Re: Ballaghveny Landfill Waste Licence Review Application - Waste Licence 78-2

ARTICLE 12 COMPLIANCE REQUIREMENTS

WASTE LICENCE REVIEW APPLICATION

ARTICLE 12 COMPLIANCE REQUIREMENTS

Title: Existing & Proposed
Leachate Management System

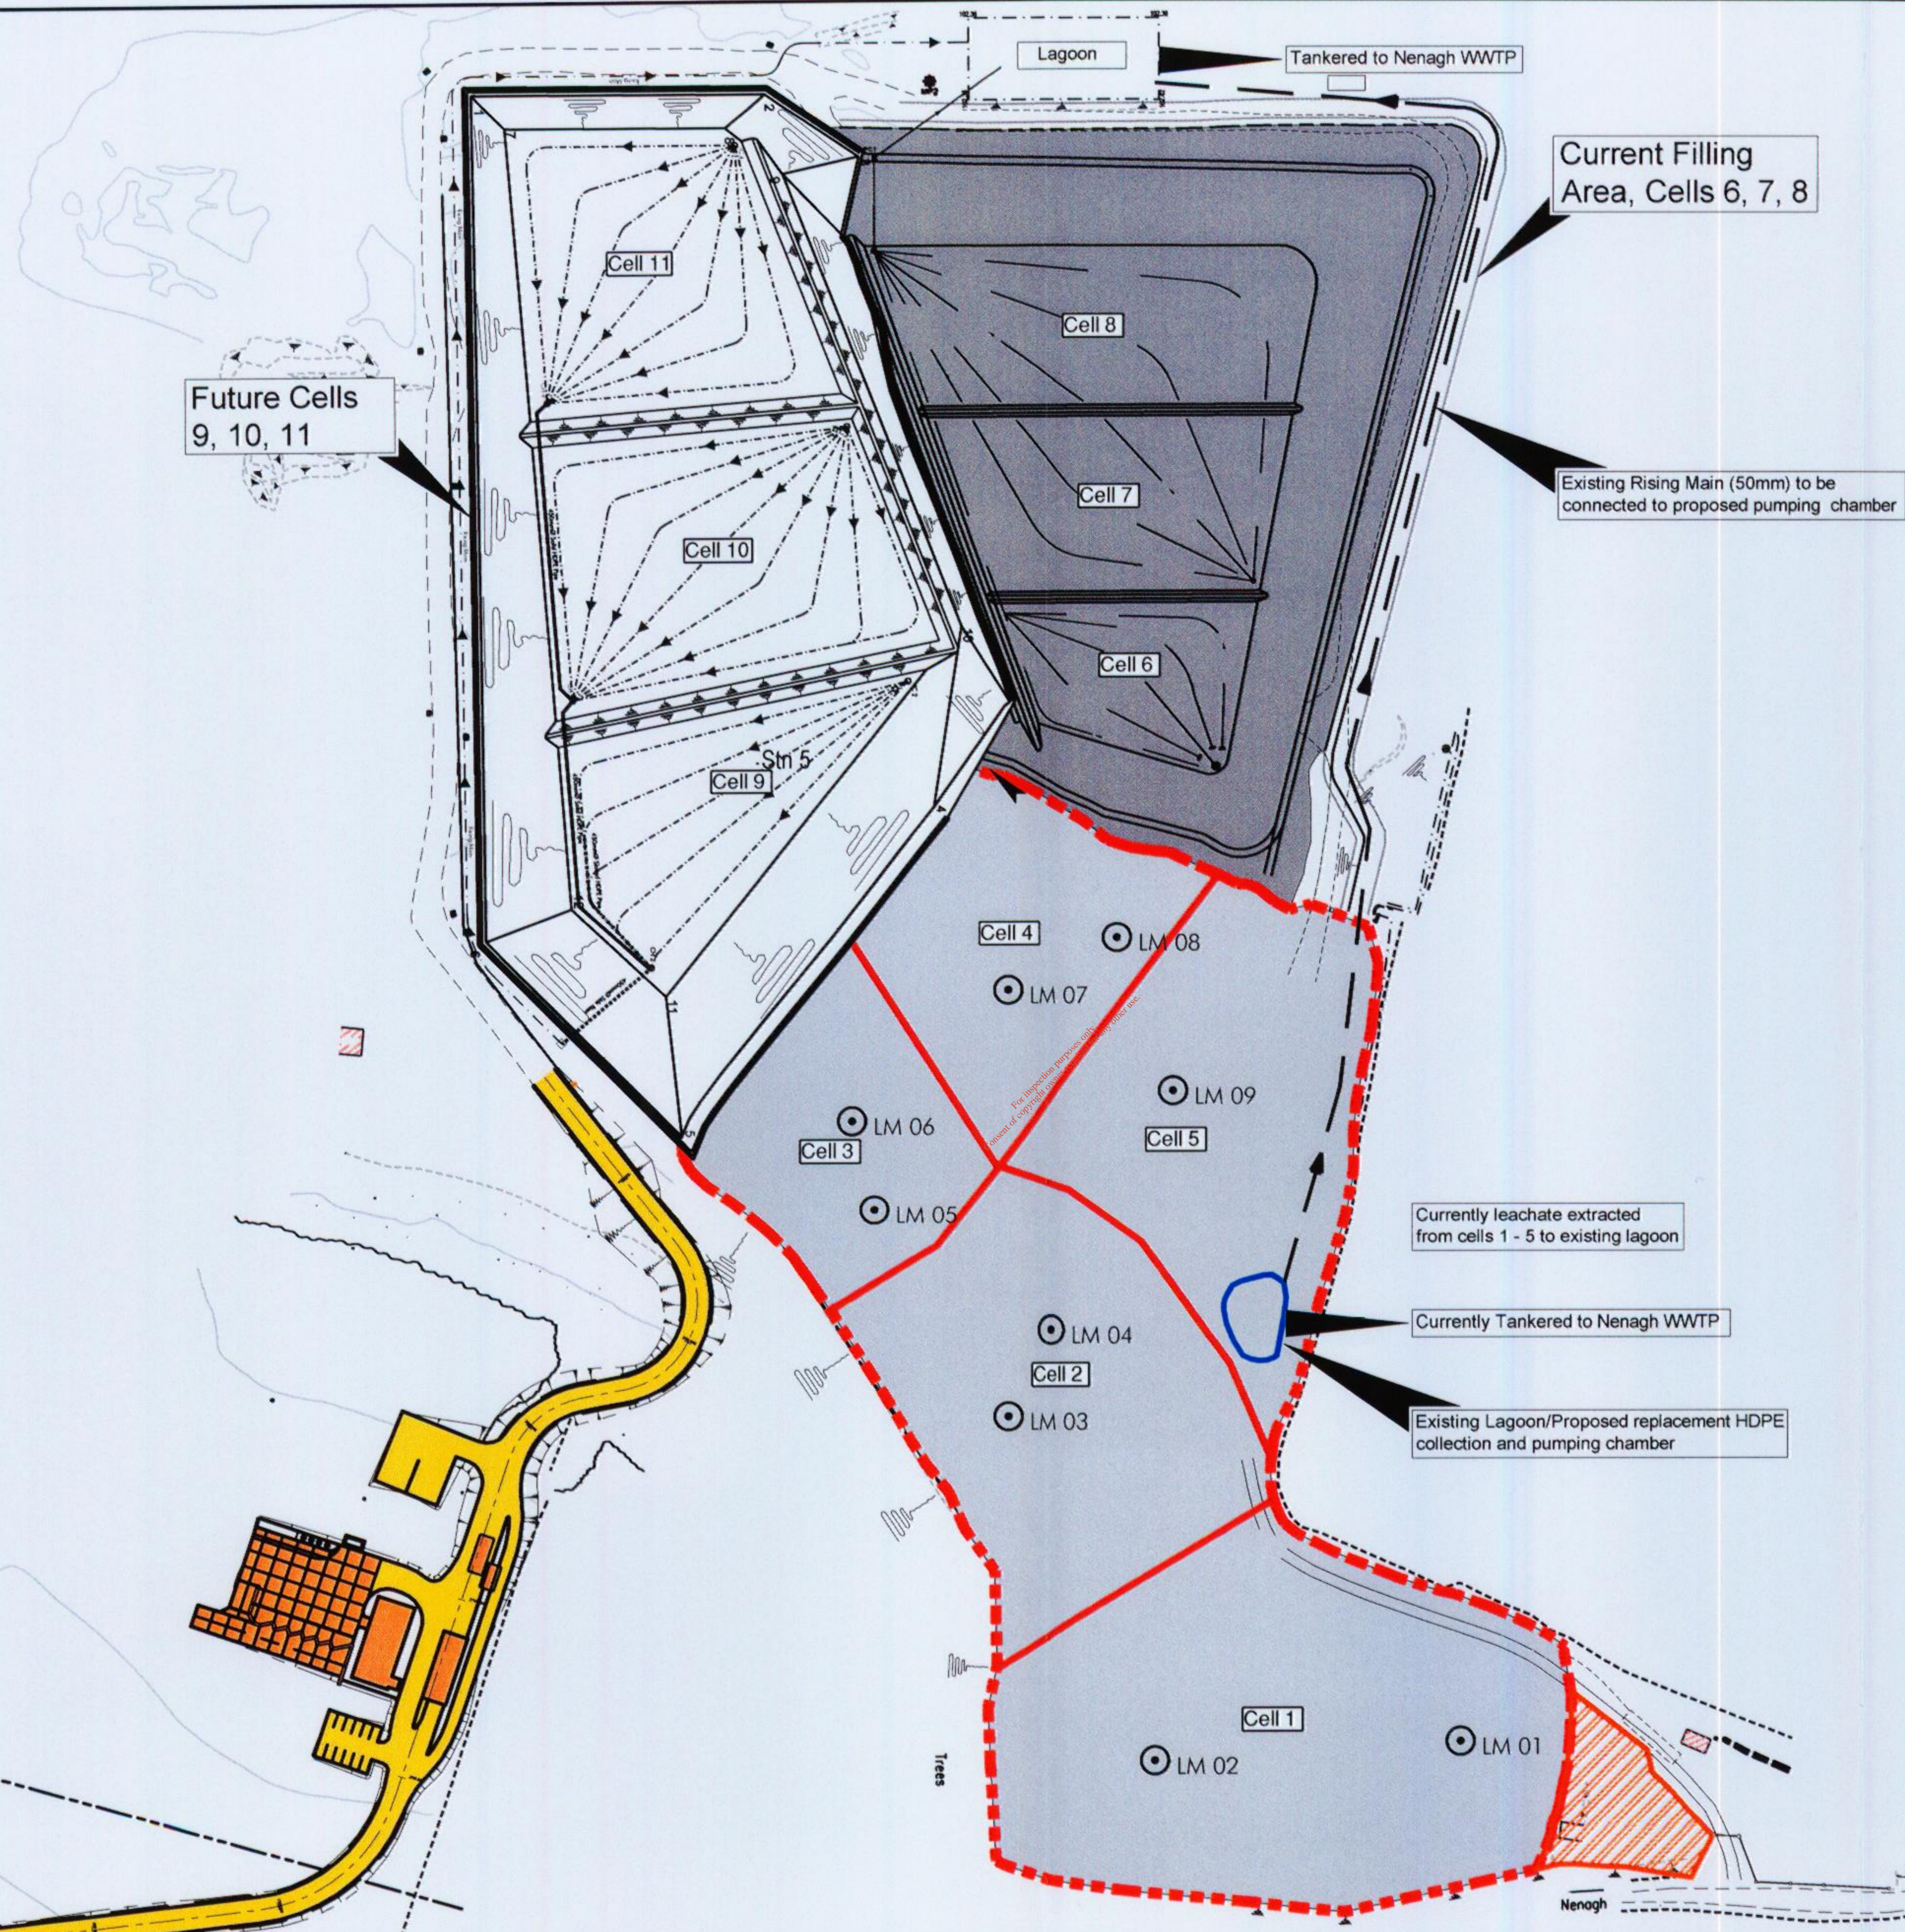
2. Provide more details on the proposed leachate collection system at the facility include a drawing showing the location of existing and proposed leachate lagoon, the associated pipe works and the existing and proposed leachate monitoring/ extraction boreholes.

Drawing No. DG0152-02 provides details on the leachate management system (existing and proposed) at Ballaghveny Landfill.

A total of 9 no. leachate monitoring/extraction boreholes have been installed within Cells 1-5 as required by the Waste Licence for the extraction of leachate from the waste body. Currently leachate is extracted from Cells 1-5 to the leachate lagoon located adjacent to the cells. Leachate is also collected from Cells 6-8 to the lagoon located at the northern end of the site. Leachate is tankered from both lagoons to Nenagh WWTP for final treatment.

The proposed restoration works contract includes for the decommissioning of the lagoon adjacent to Cells 1-5 and replacing it with a pumping/collection chamber and connecting to the lagoon constructed to the north of Cells 6-8. A leachate rising main will transfer the collected leachate from the new pumping/collection chamber to the lagoon north of Cells 6-8. Leachate collected and stored in the lagoon will then be tankered to Nenagh WWTP. Leachate will continue to be extracted from Cells 1 and 2 to the new pumping/collection chamber and pumped via the rising main to the lagoon. A

telemetry control system is also proposed to monitor leachate levels within the landfill and the lagoon and to provide a control to the leachate management system. Future Cells 9-11 will also be connected to the leachate management system when operational.

Fig. 2A - LANDSCAPE LAYOUT

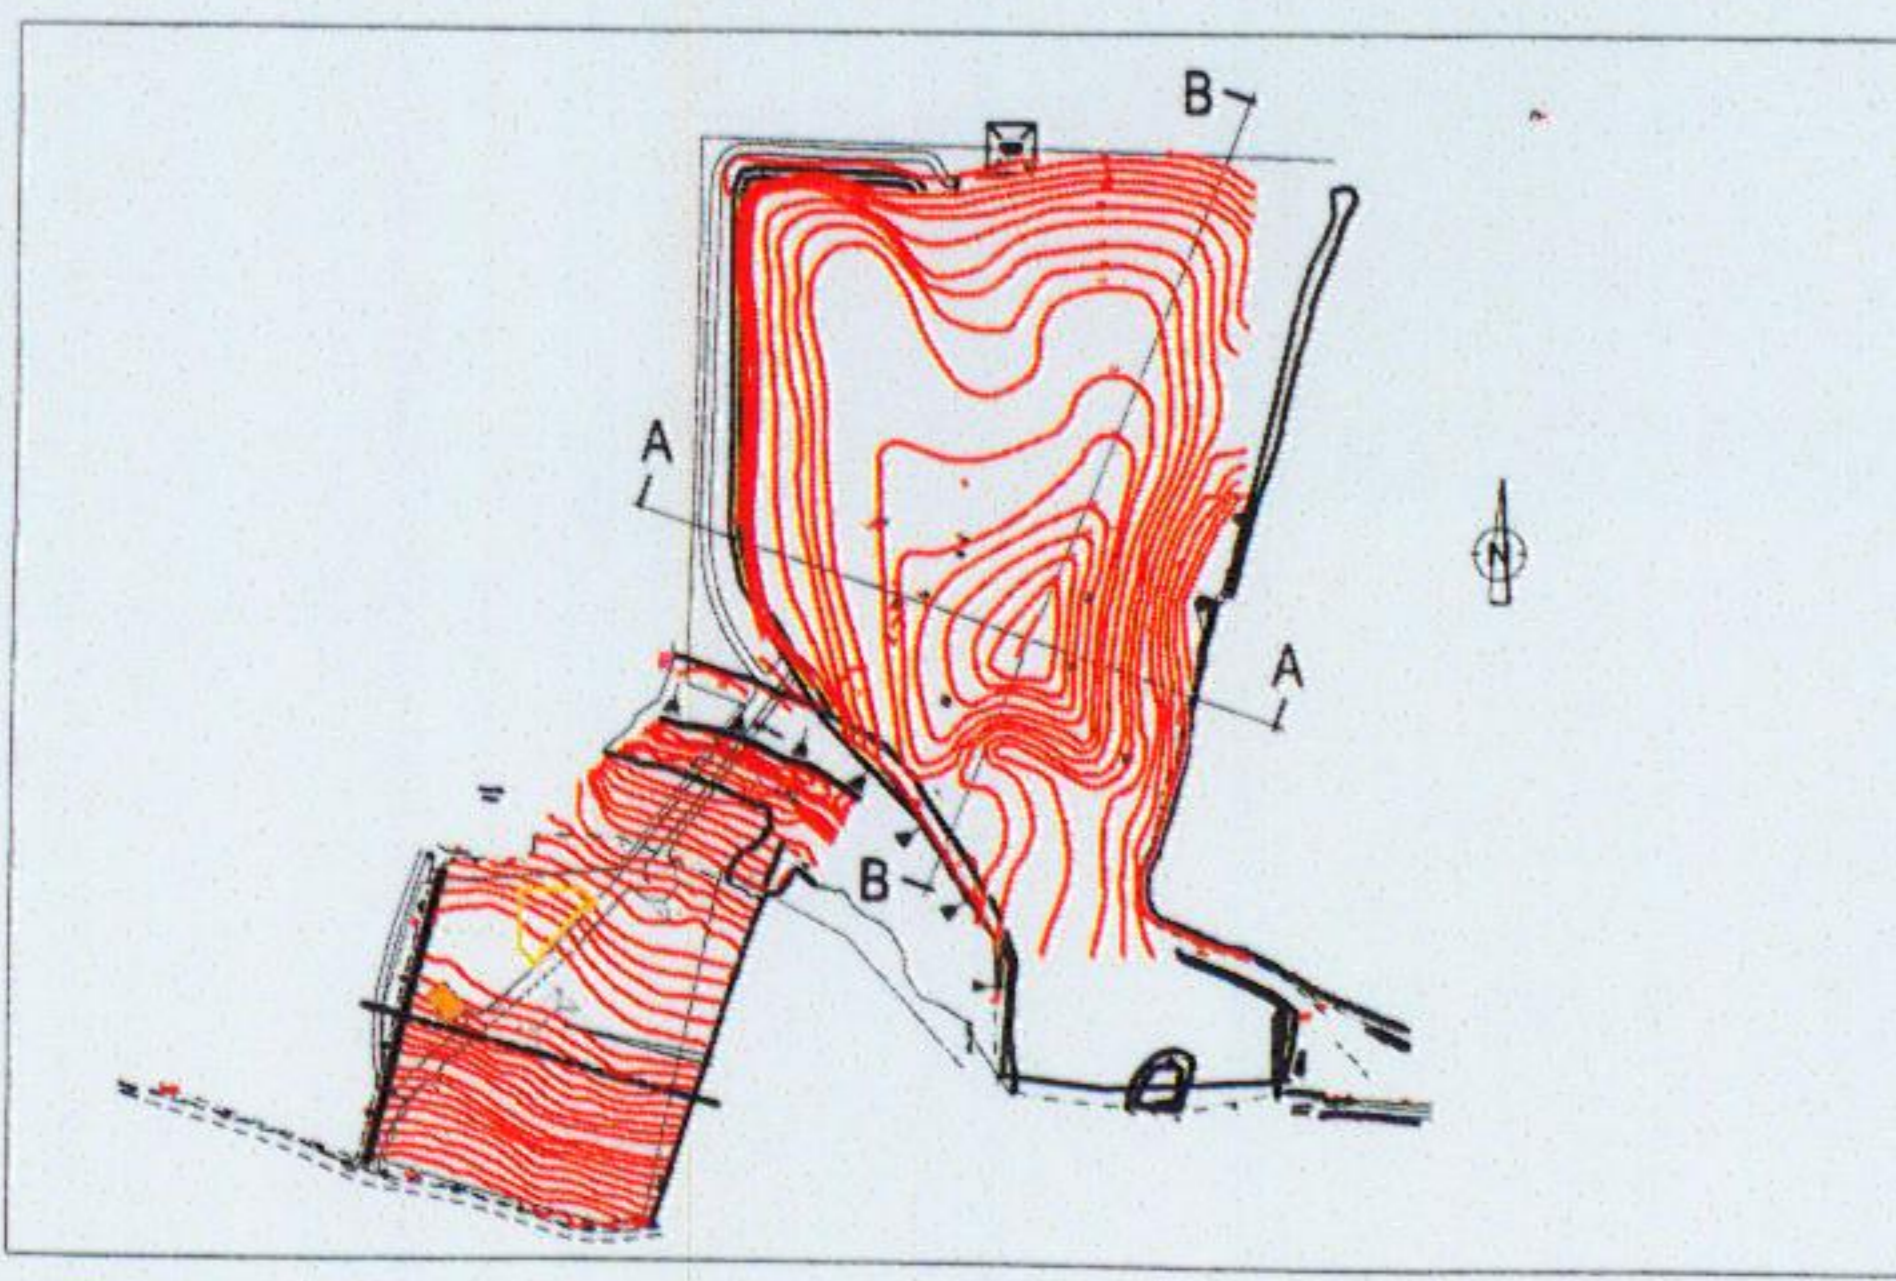
Clarify the discrepancy between the statement in Section 4.7 Environmental Impact “Mitchell & Associates concluded that the overall visual impact will not be significant and neutral.....” with the statement in the actual report by Mitchell and Associates, Landscape Architects (contained in Appendix C) stating “in the case of all three view points the overall visual impact is significant and neutral.”

We also inform the Agency that Figures 2 and 3 of the Visual Impact Assessment prepared by Mitchell & Associates have been updated and contours revised to correlate with the proposed final design levels included in the proposed restoration works contract for Cells 1-5. These revised figures also indicate the proposed final contour levels for the remaining Cells 6-8 and future cells 9-11 where the maximum height of 114mOD is not exceeded. The revised figures are included in Appendix A.
